RE: October 31, 2000 fax to Cubic Communications, Inc., Mr. Clive Winkler
FCC ID: NVSMTC-100TMCPA

Re: Application dated 10/11/00 and granted 10/31/00
Applicant Name: Cubic Communications Inc
Equipment Class: TNB-Licensed Non-Broadcast Station Transmitter
FCC ID: NVSMTC-100TMCPA

Under the authority of Section 1.113 of the Commission's Rules, the above referenced Grant of Equipment Authorization is hereby SET ASIDE.

Data and Plot of the Output Bandwidth vs the Audio Input Level.

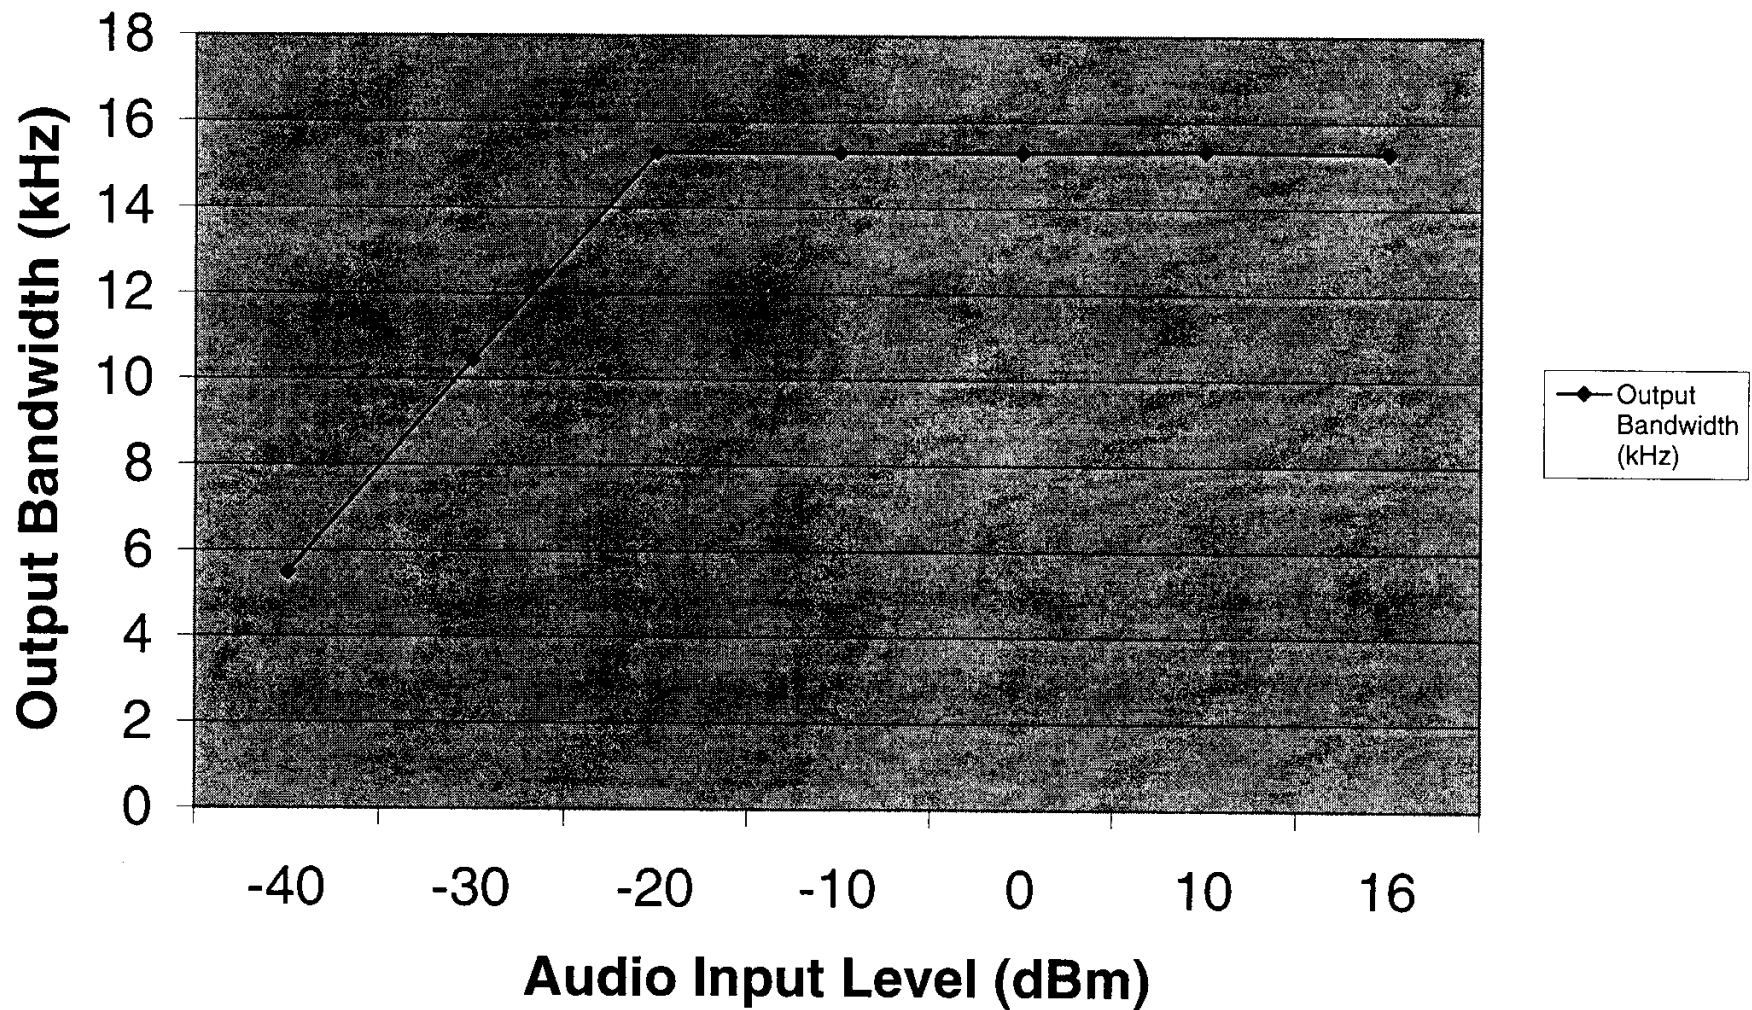
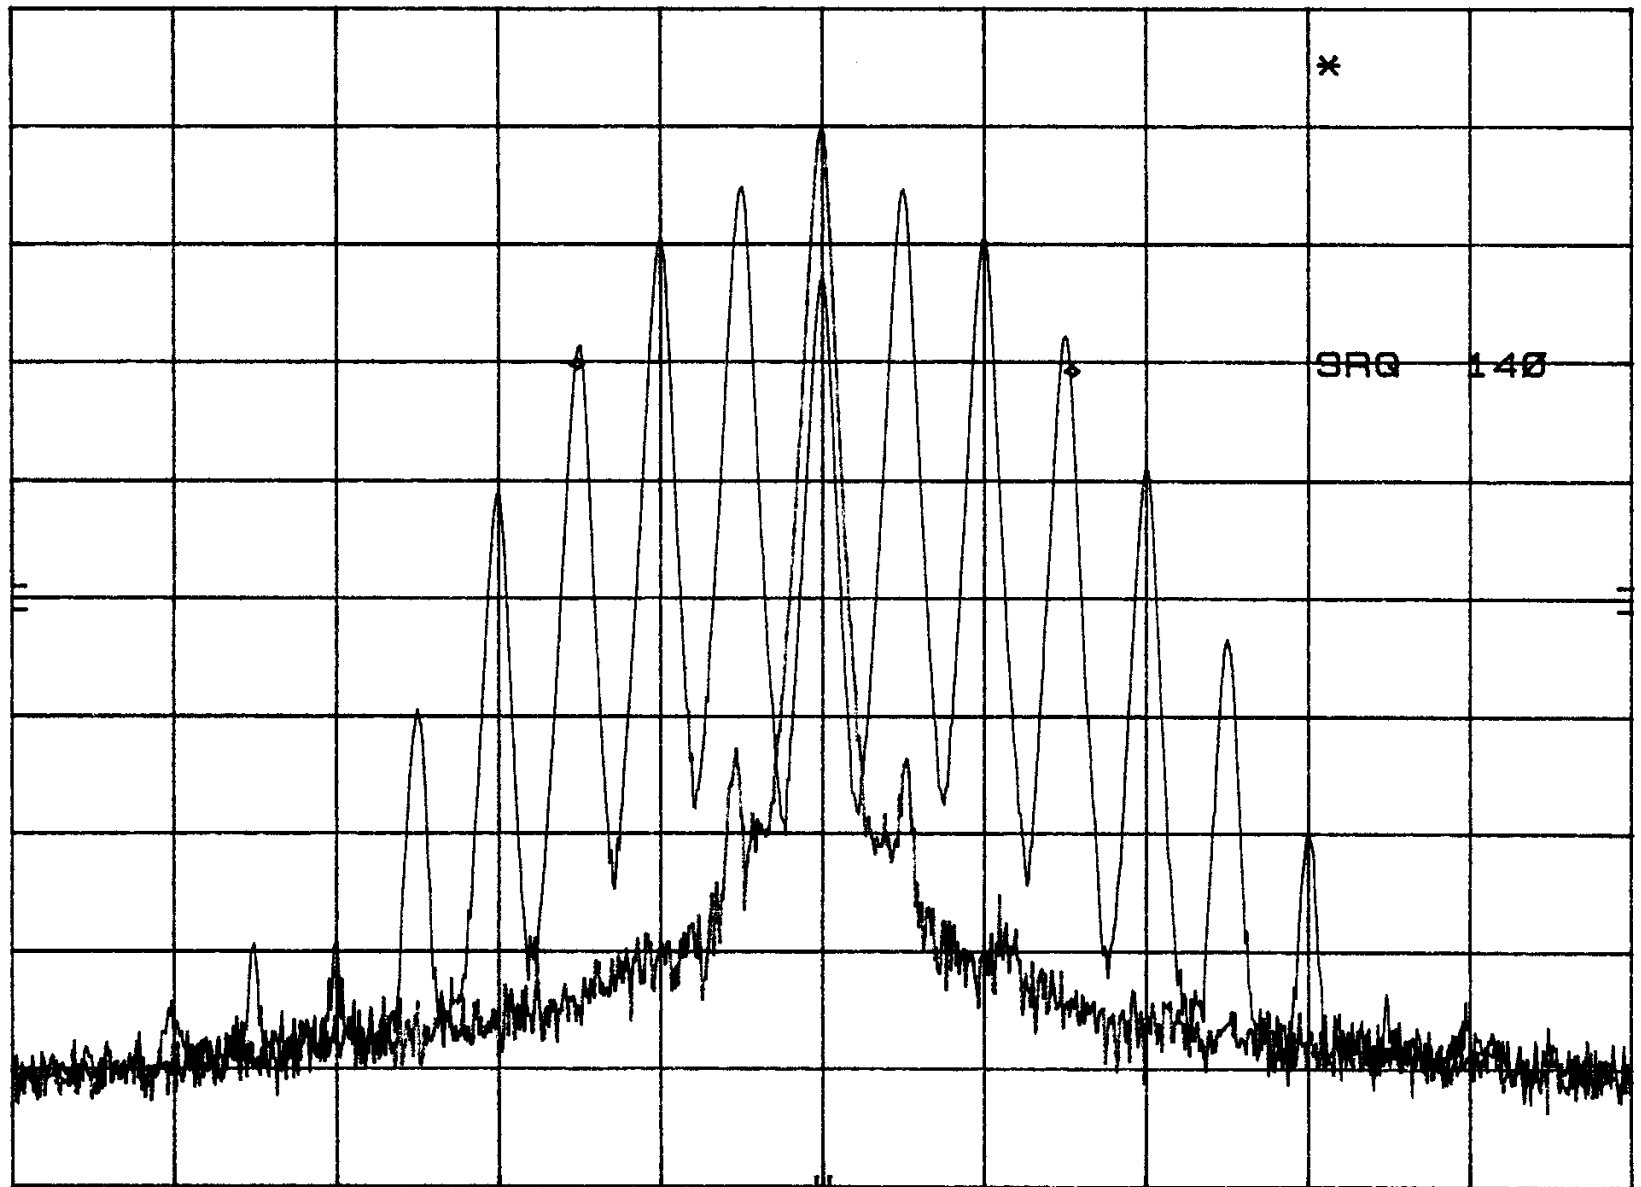
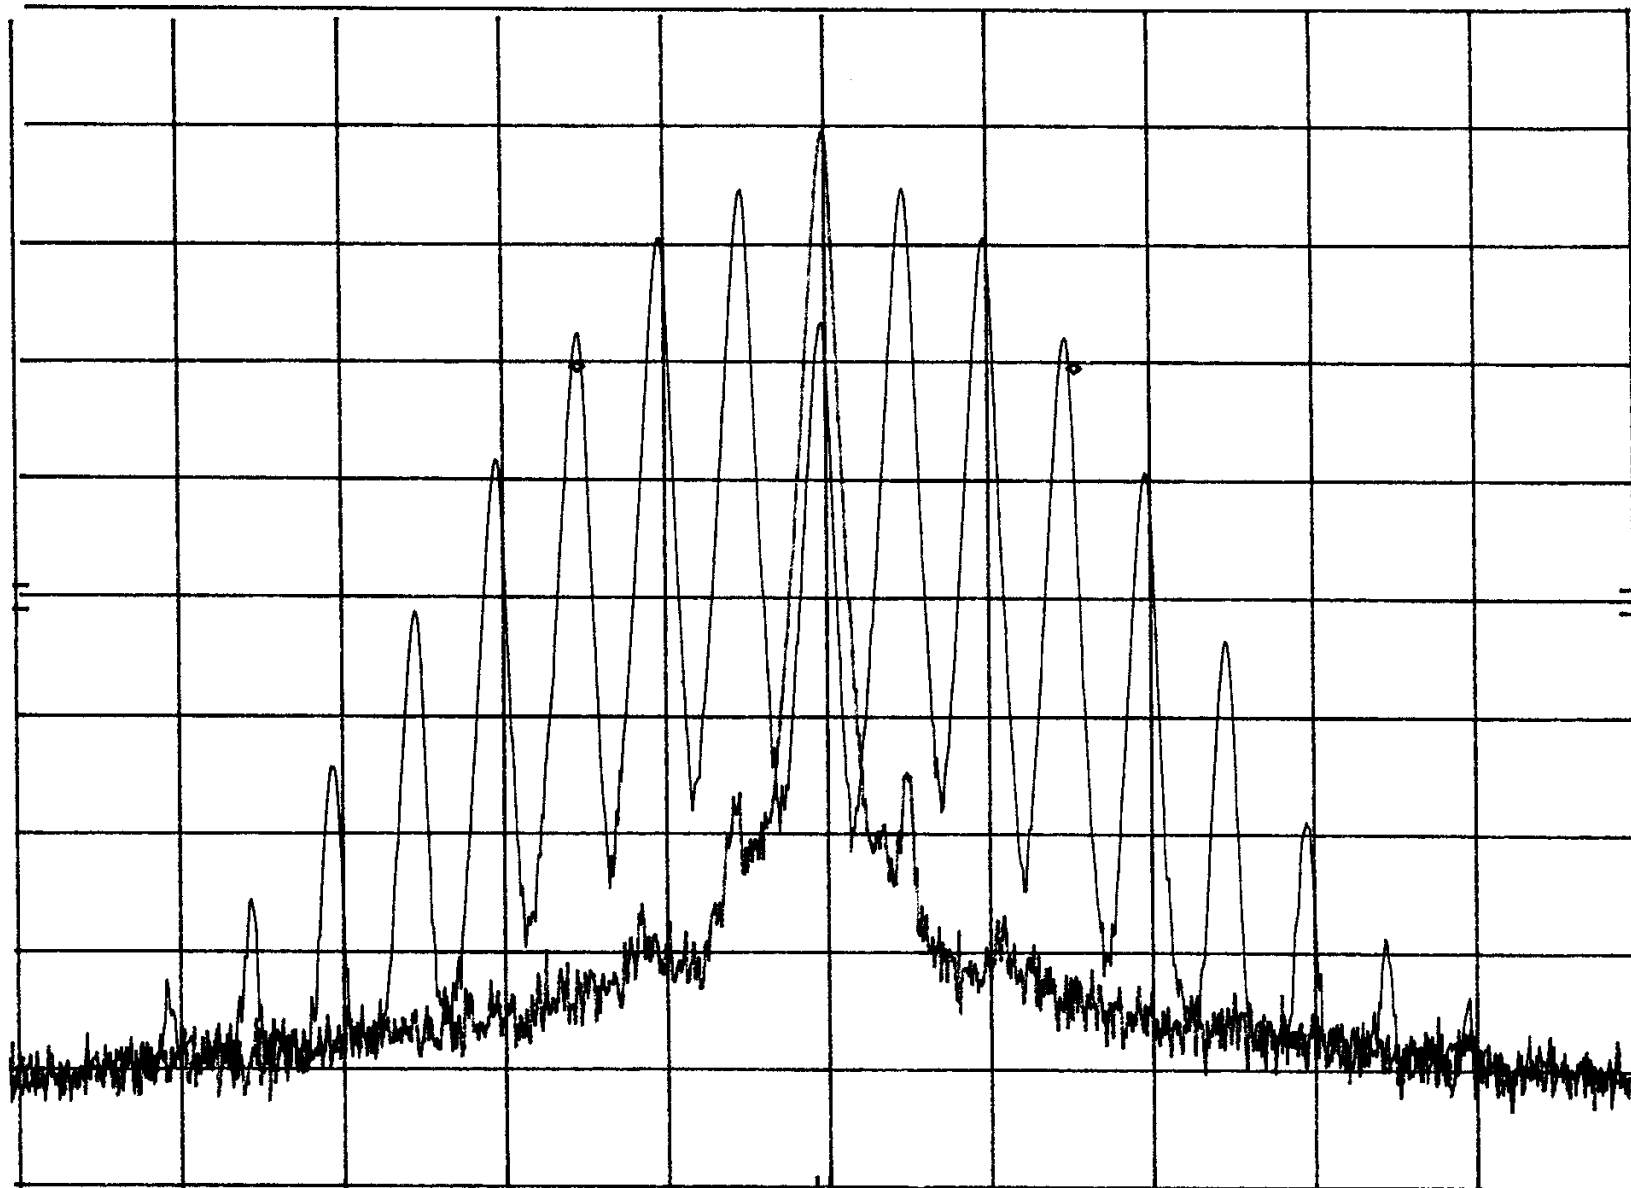
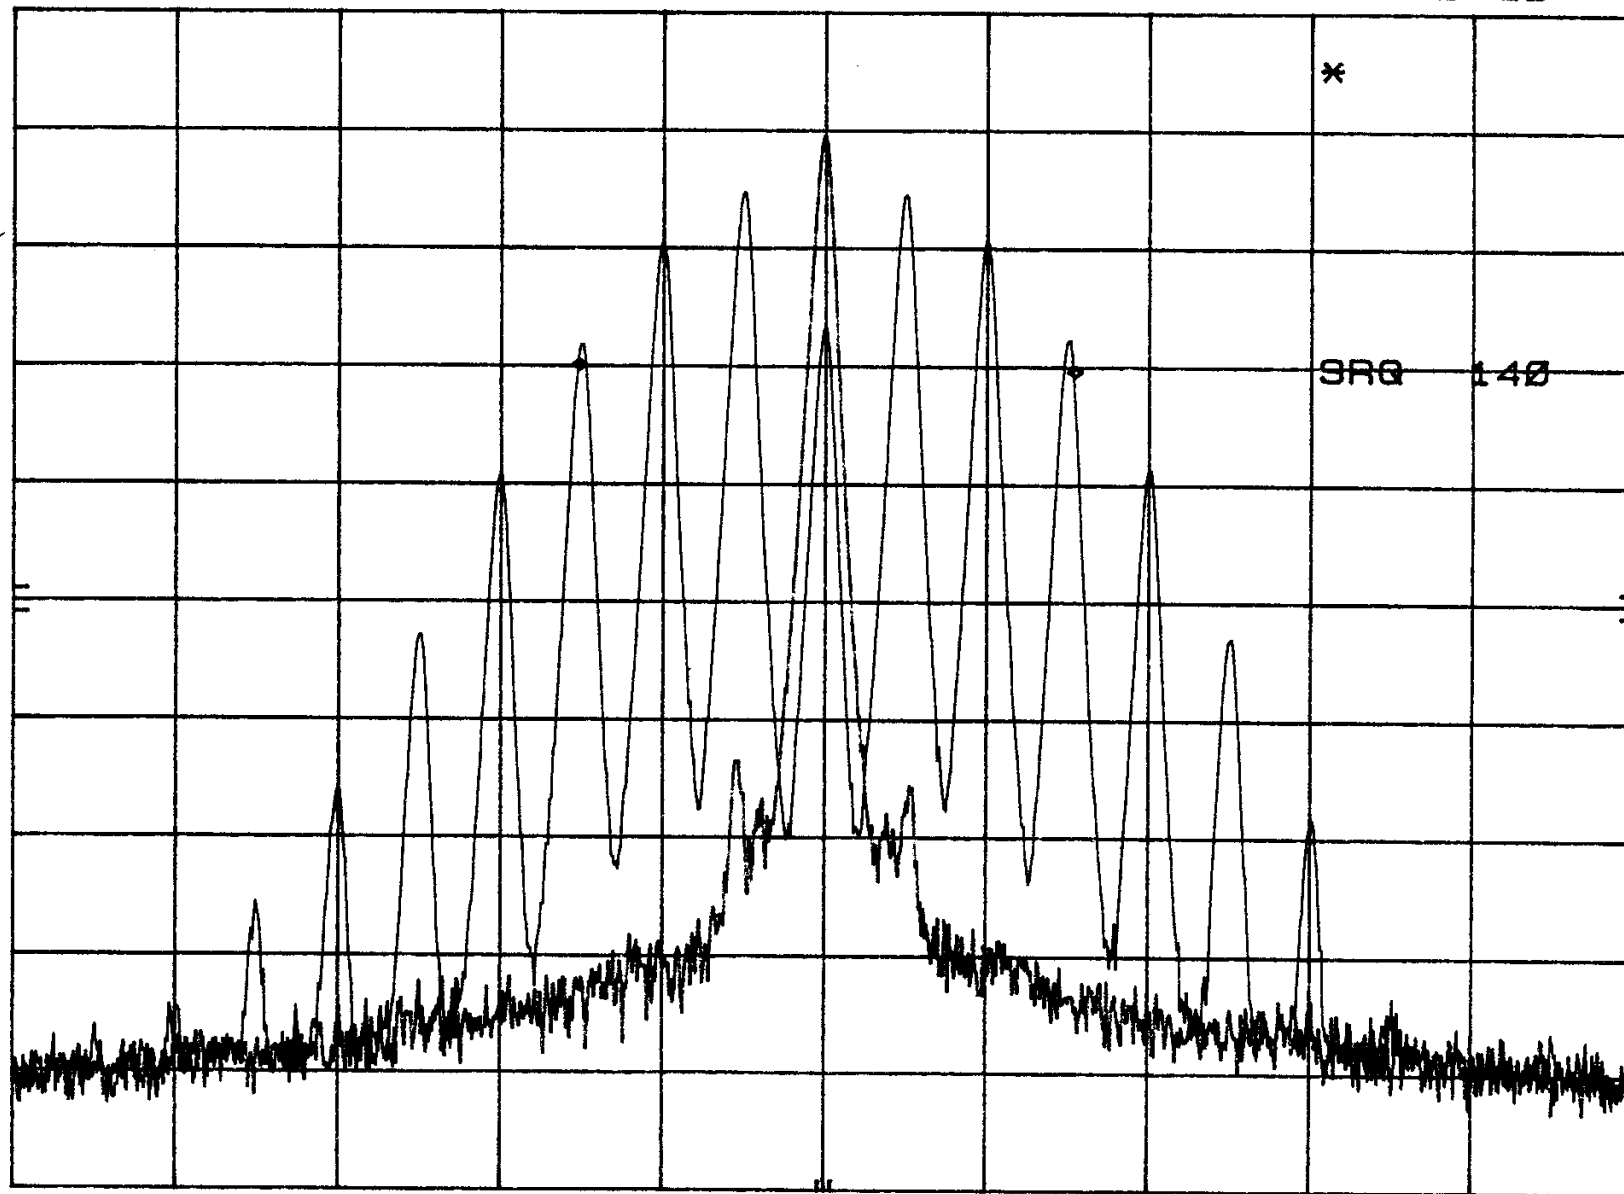
1. Modulation limiting data required by Section 2.1047(b) of the FCC Rules was not submitted.
2. The occupied bandwidth test was not made with the 2500 Hz tone prescribed by Section 2.1049(c)(1) the Rules.
3. No response to the audio low-pass filter requirement of Section 80.213(e) was given.
4. No response to the frequency selection capability of Section 80.203 was given.
5. No response to the DSC requirement under Section 80.203(n) and 80.225 was given.
6. For your information - Please note that the attenuation requirement for unmodulated spurious emissions is prescribed as $43 + 10\log(P)$. This is referenced to the desired signal yielding a level referenced to the carrier or dBc. The attenuation specification is not a specified field strength level or $\mu V/M$. The dBc is determined from the substitution method as described in the ANSI/TIA/EIA-603-1992 document.

“Modulation limiting data required by Section 2.1047(b) of the FCC Rules was not submitted.”

We have attached measured data taken on 11/21/00 according to this specification.

See page 4 for the plot of the data and pages 5 through 11

16	15.29
10	15.34
0	15.29
-10	15.29
-20	15.29
-30	10.45
-40	5.50
